MEMORANDUM

REQUEST FOR PLANNING PROPOSAL 251, 260R, 278 AND 280-282 CAPTAIN COOK DRIVE, KURNELL

Author(s)	Sunil Shrestha
Entity	Civil - Brownfields
Version	V07
Reference	Request for Planning Proposal 251, 260R, 278 and 280-282 Captain Cook Drive, Kurnell

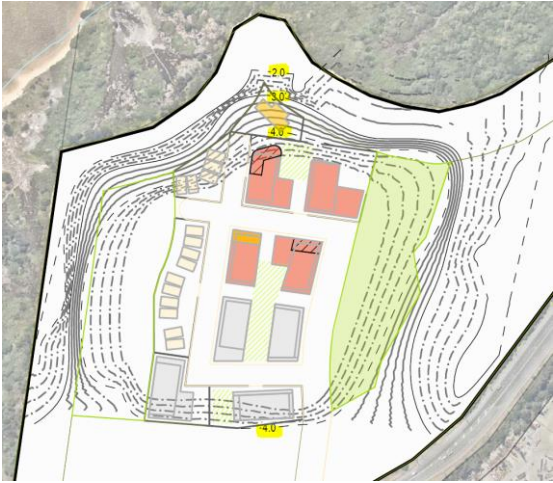
As requested in the comments from relevant departments, the hydraulic modelling and maps have been updated to assess and determine the effects of climate change and sea level rise for the wider catchment area.

Council SLR policy states that sites over RL2.22m AHD do not need to consider SLR. Given the site is higher than this level, Sea Level Rise is not a typical consideration for sites such as this, in terms of the effects of the habitable space within the development. However, due to the concerns raised, SLR and tidal impacts have been considered as part of the updated flood report and maps.

The overall worst-case scenario has been modelled for the site, and the findings show that the sea will not rise to inundate the site. However, sea level rise could potentially affect the internal stormwater pipe drainage and internal overland flow paths as it will impact tail water conditions on these systems and reduce the capacities of the systems. Additionally, any required freeboards to pit grates would need to be checked as part of the detailed design under the SLR condition. This will be investigated during the DA stage. It is important to note, however, that this is a broad issue faced by Sutherland Shire and not an impact associated with the proposed development in isolation.
